C-900 - ADDENDUM

Addendum No. 2

Date:	<u>March 27, 2019</u>
Issued To:	<u>Plan Holders</u>
From:	<u>Alan Plummer Associates</u>
Project:	<u>Wastewater Treatment Plant Expansion</u>

Village of Taos Ski Valley Wastewater Treatment Plant Expansion Pre-Bid Meeting Agenda March 18, 2019 – 1:00 PM

MICROBLOX SKID NO. 1 P&ID

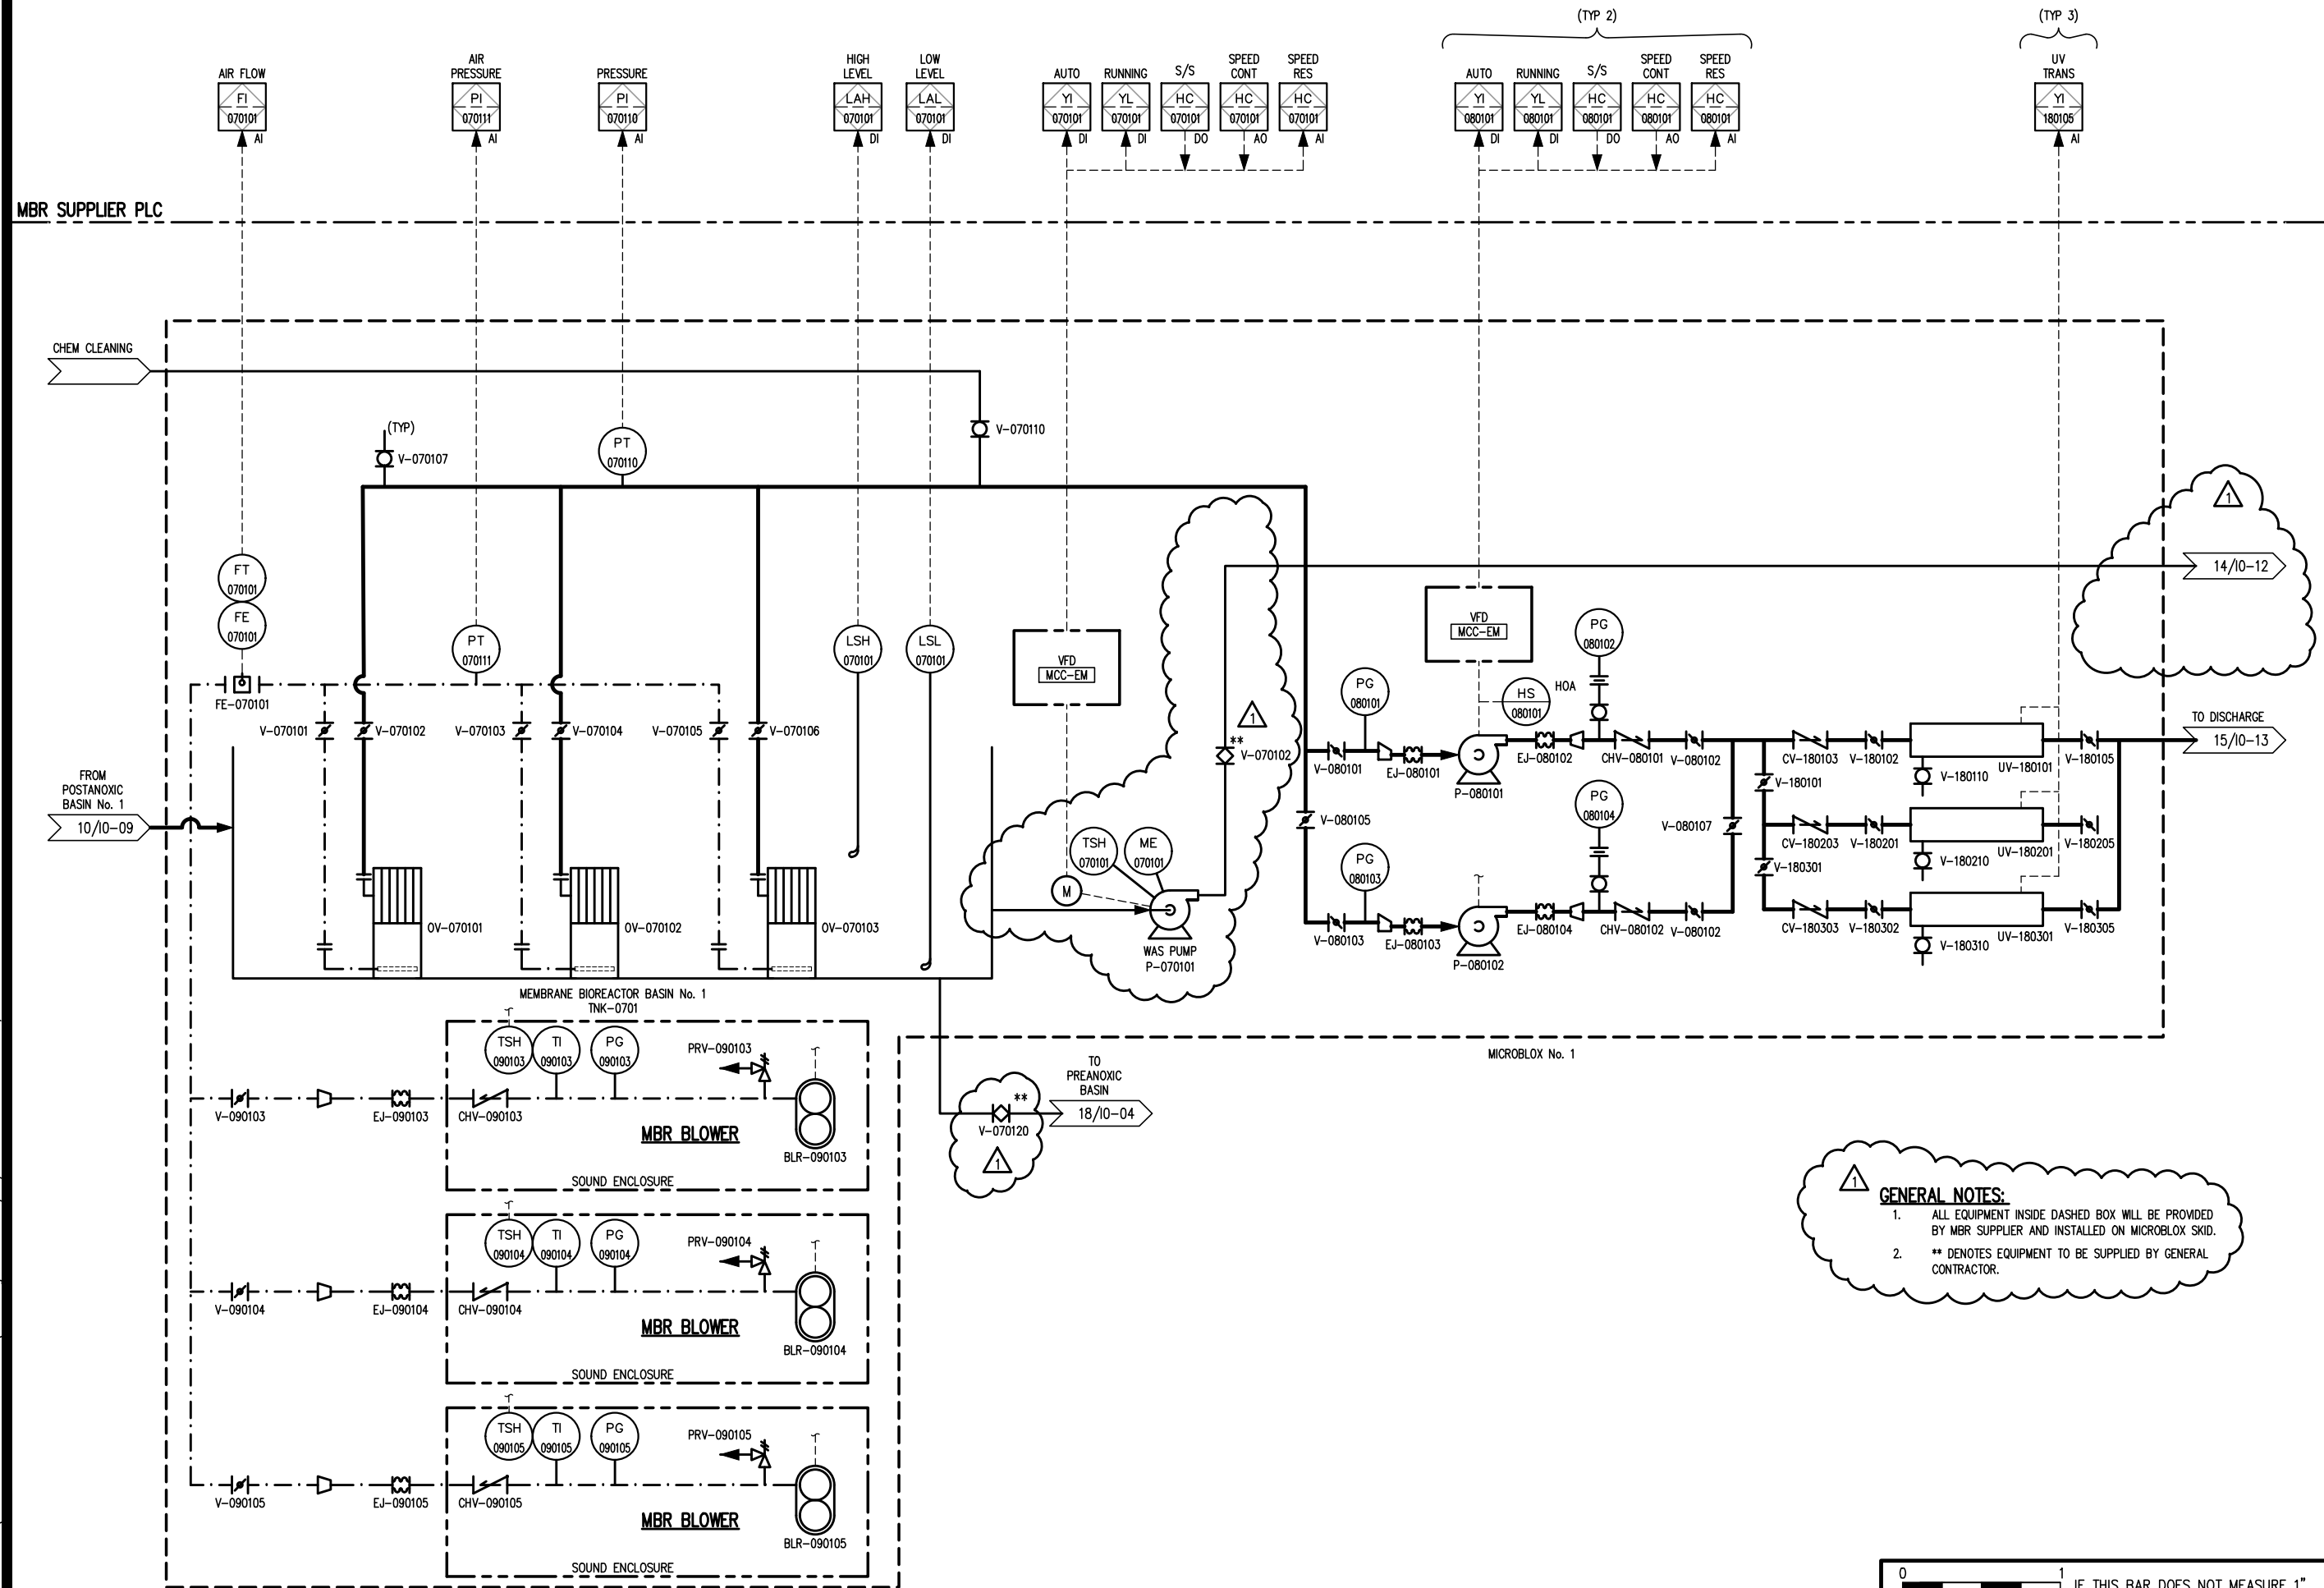
- E. Inst. Sheets I0-11 and I0-12: Within the dashed line indicating the Microblok Skid are valves that alternately have or do not have an * indicating that they are to be provided by MBR Supplier. Will ALL Valves etc. within the dashed line be by MBR supplier whether or not they have an *?

1. Response: Refer to revised Sheet No. I0-4 included in this Addendum.
- G. Plan Sheet P1-04 & P3-04: Both dwgs show 4" Plug Valves (note #4) and 4" Elec. actuated Plug Valves (note #6). What are these Valve Tag #s on the P&IDs? Are these valves provided by the MBR Supplier?

1. Response: Refer to revised Sheet No.'s I0-11 and I0-12 included in this Addendum.
- F. Plan Sheet P1-04 & P3-04: Both dwgs show an 8" Flow Meter on what becomes the 14" RAS Line. Does this Flow Element appear in the P&IDs? It appears that this Line is represented in the P&IDs on sht I0-11 and I0-12 and continued @ 18/I0-04 & 22/I0-04, and no meter is shown on this line.

1. Response: The 4" plug valves identified in this question are not provided by the MBR Supplier. Refer to revised Sheet No.'s I0-11 and I0-12 included in this Addendum.

EXISTING TREATMENT BUILDING
UPPER LEVEL PLAN

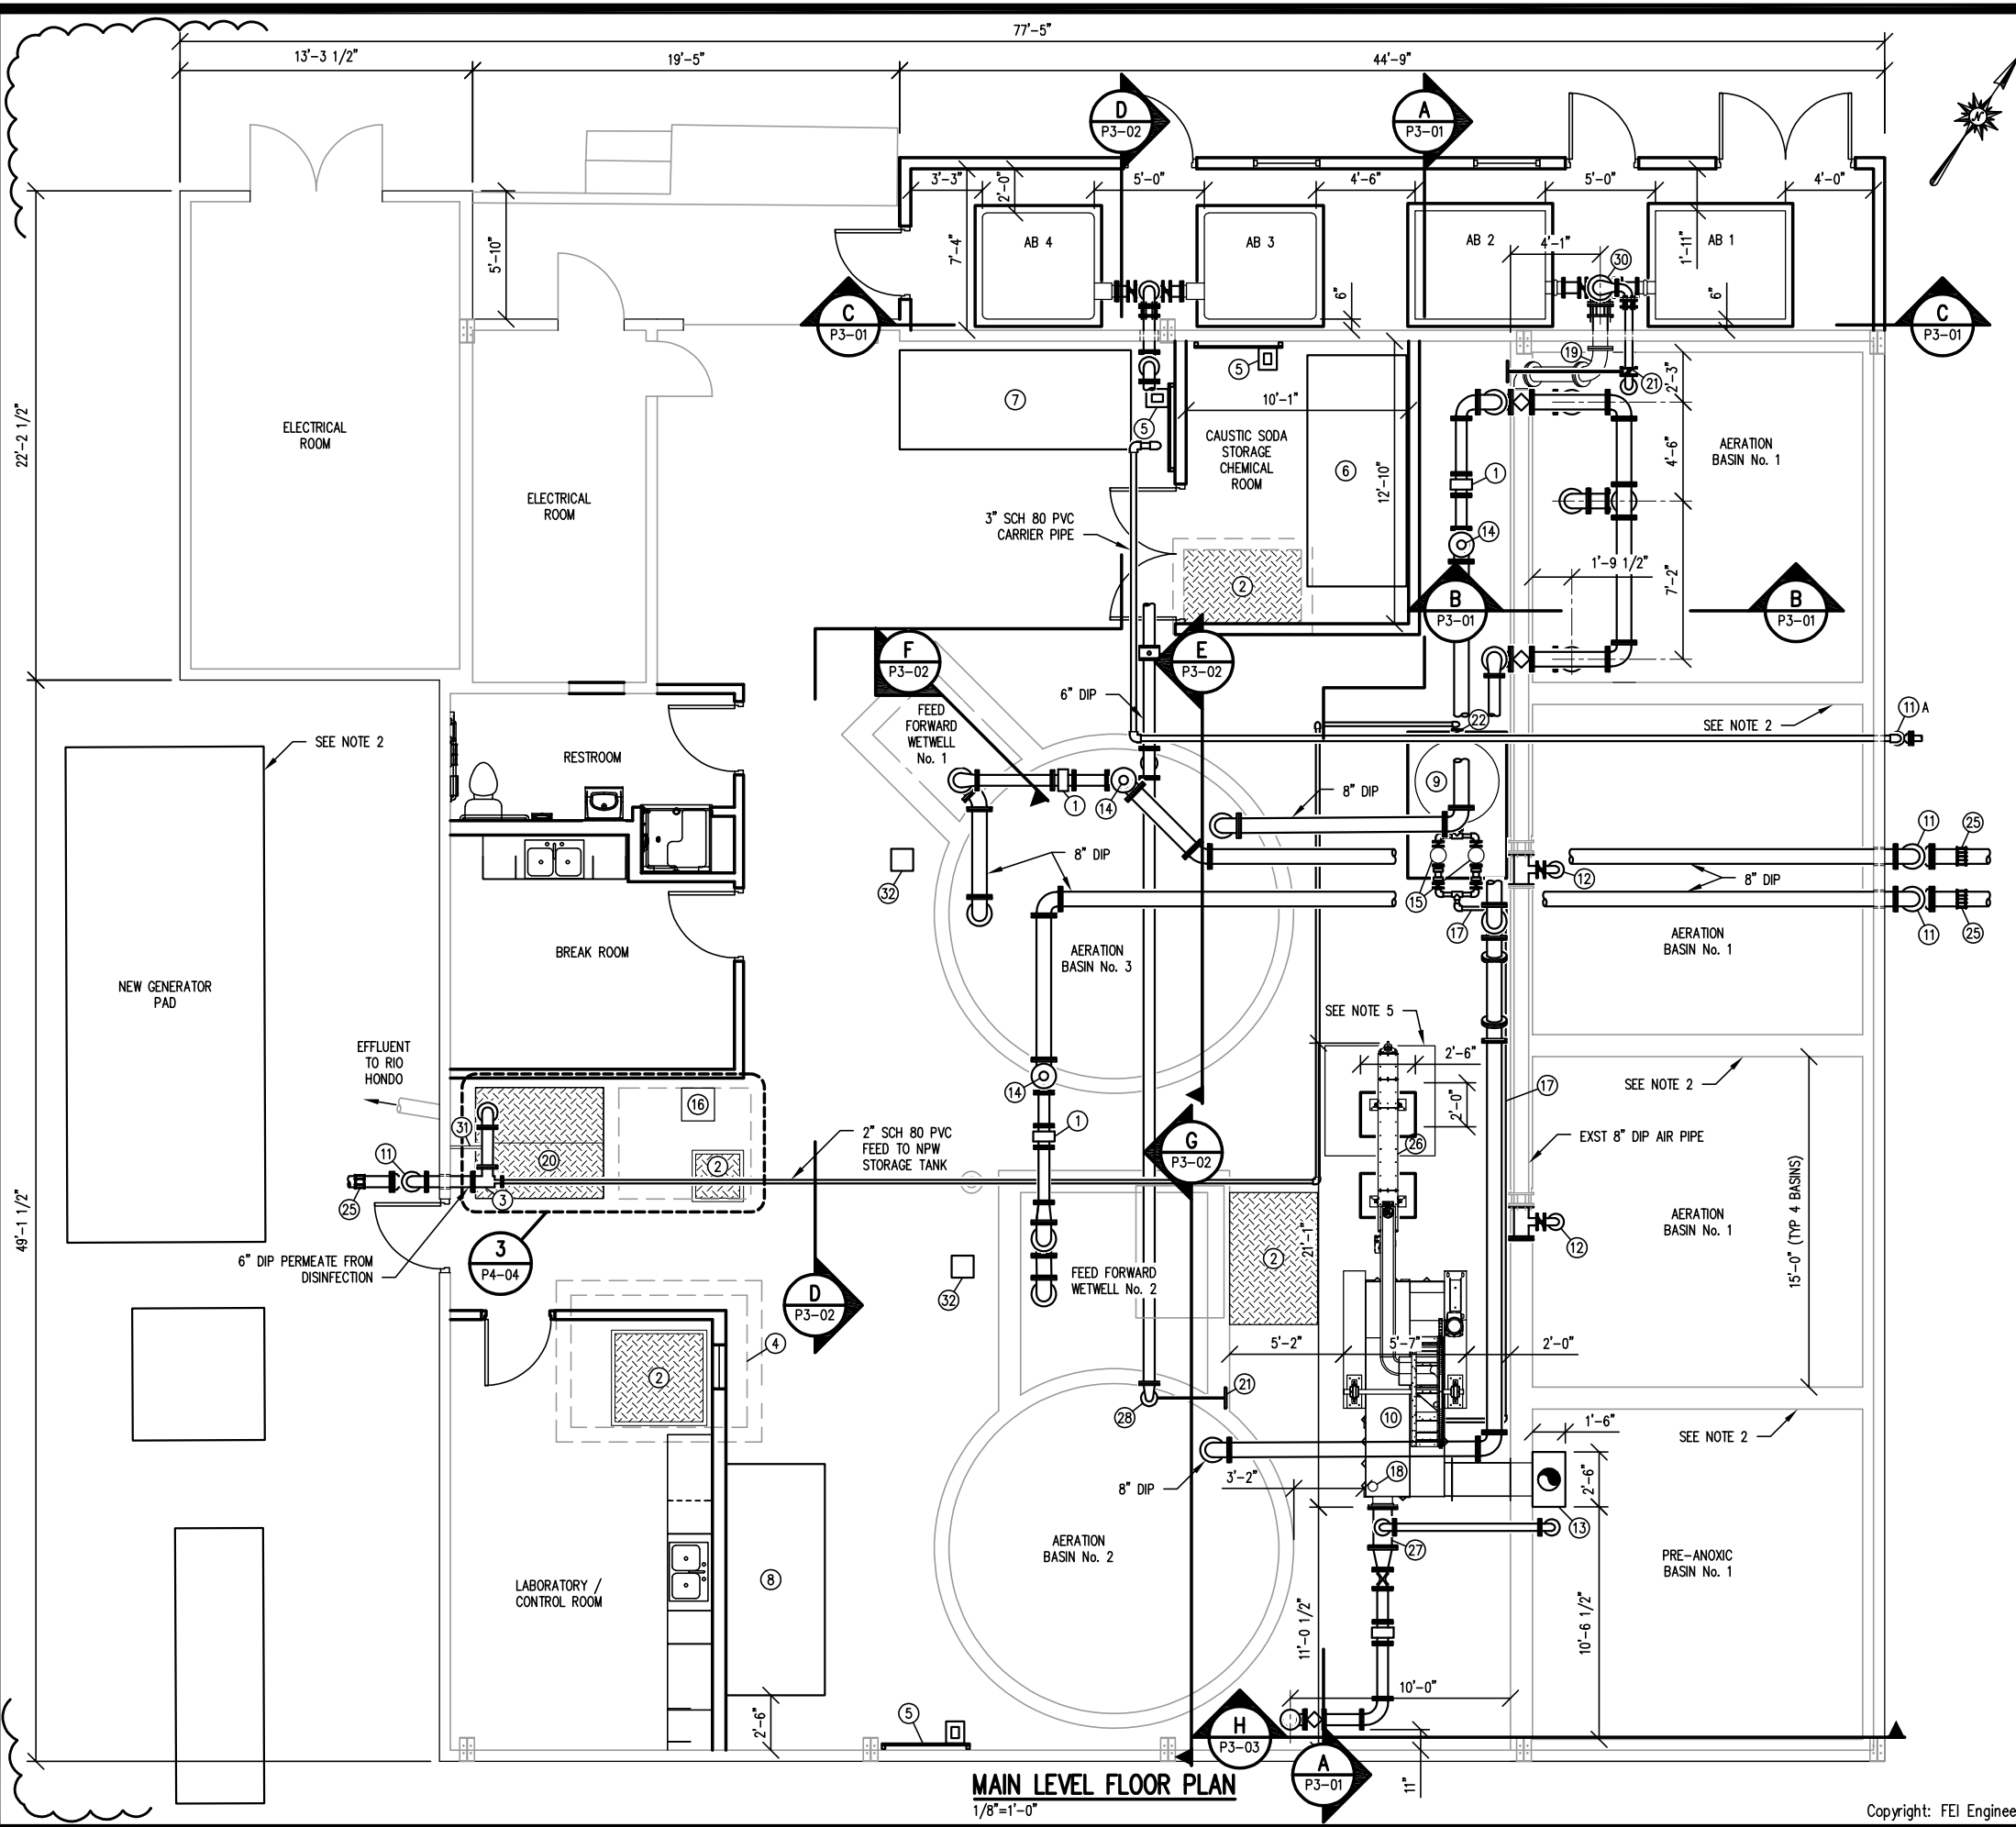
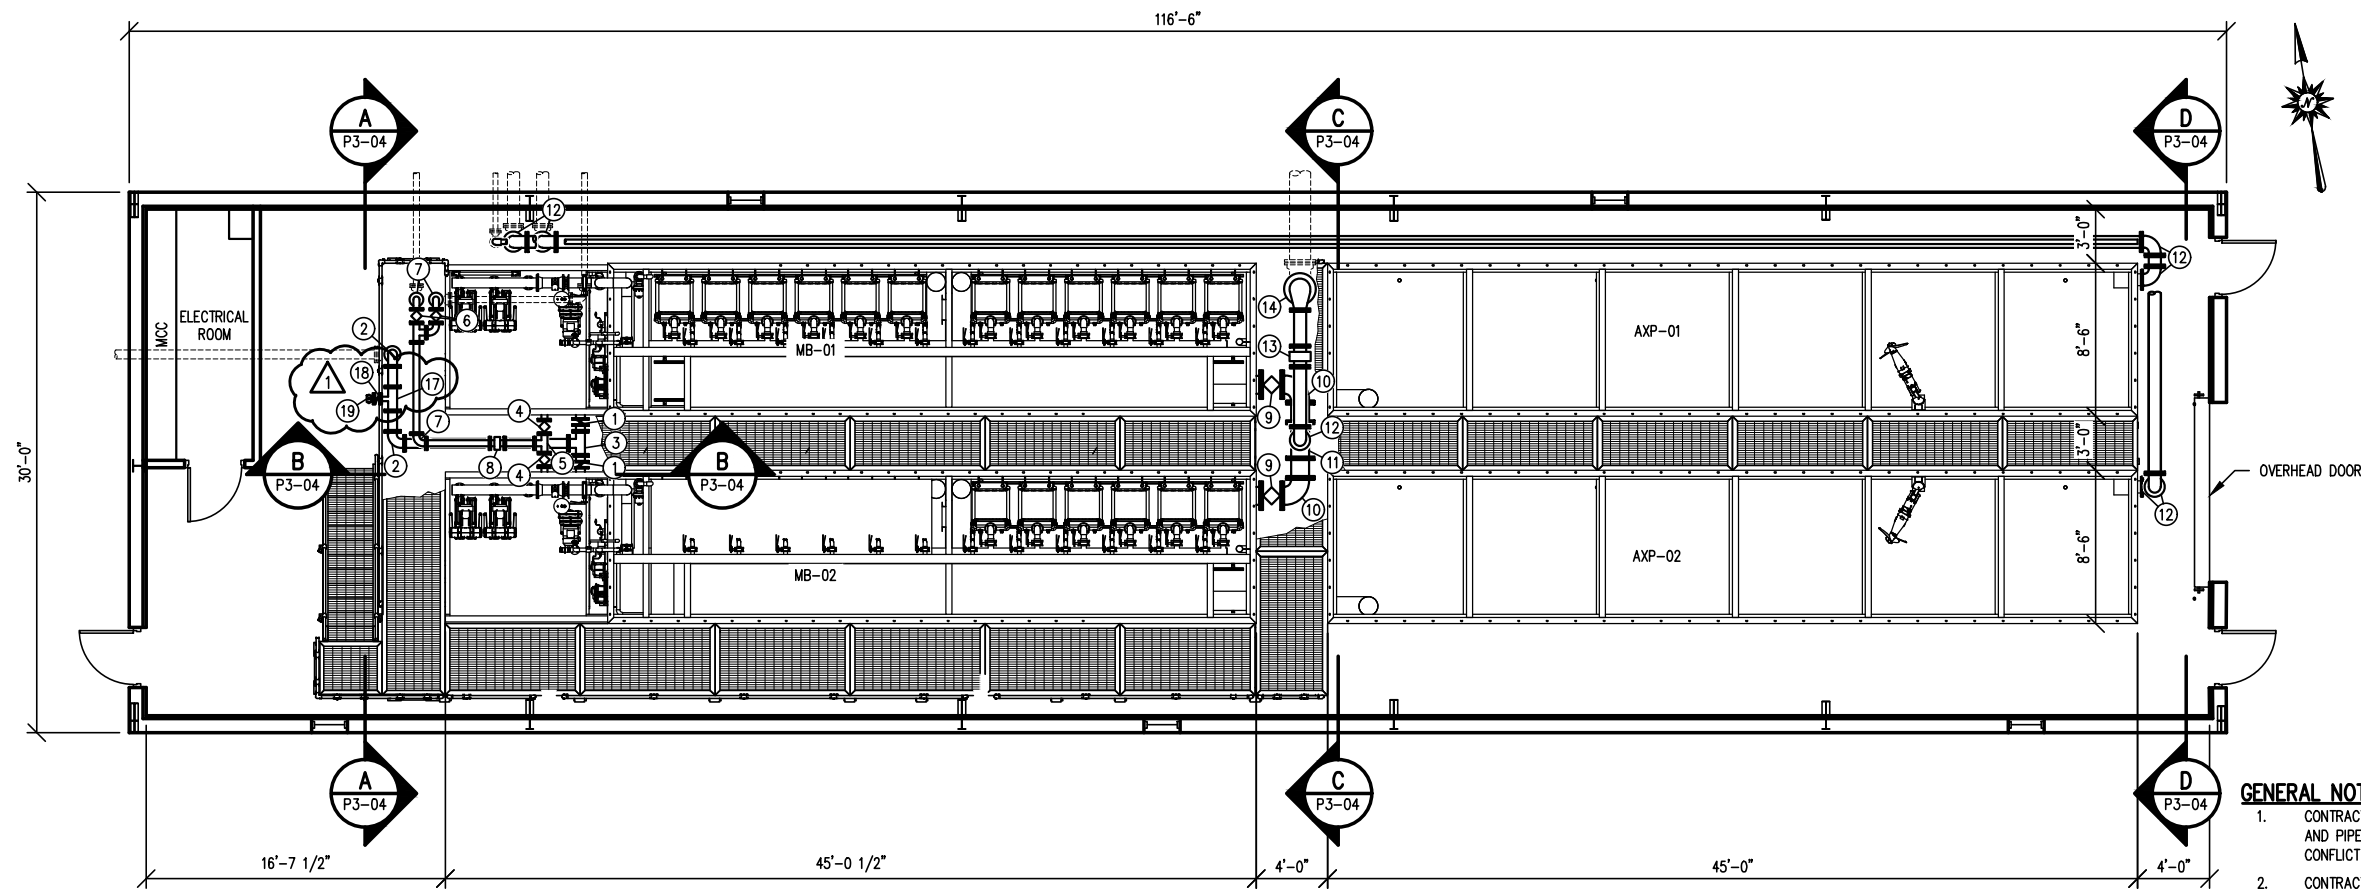
- C. P1-02 - what is spec of 500g NPW storage tank?
 - 1. Response: Refer to revisions to Sheet No. P1-02 included in this Addendum for the tank manufacturer/model.

- D. Are equipment pads required beneath the drum screen, screw press?
 - 1. Response: Equipment pads are not required under drum screen. Provide equipment pad under screen screw press; refer to revised drawing P1-02, included in this Addendum.

- I. Plan sheet P1-02: Where the 3" Micro-C Line leaves the building, should this pipe be insulated? Please detail.
1. Response: Refer to revised Sheet No. P1-02 included in this Addendum.

- J. Plan Sheet P1-02 and I0-13: Plan shows 2-EA NPW Pumps with BFV Valves on each side, while P&ID shows 1-EA Pump w/ Check Valve and Butterfly Valve. Please Clarify what will actually be installed.

- K. Sheet P1-02, Note #21: Note calls for 4" BFV w/ Long Stem Handwheel Operator, What is this Valves Tag #s on the P&IDs? Is this valve provided by the MBR Supplier?

1. Response: Provide a BFV on each side of each pump and a check valve on the discharge side of each pump. Refer to revised Sheet No.'s P1-02, P3-01, and I0-13 included in this Addendum.

1. Response: The valve will be provided by the Contractor. The Tag for valve as V-050113.
- L. Plan Sheet P3-01, Section C, Note #13: Note calls for Expansion Joint on Process Air Pipe, symbol appears to be a Dresser Coupling. Is this actually an Exp joint? If so what is this Exp Joint's Tag #s on the P&IDs? Is this Exp Jt. provided by the MBR Supplier? If not please provide a reference to correct specification.
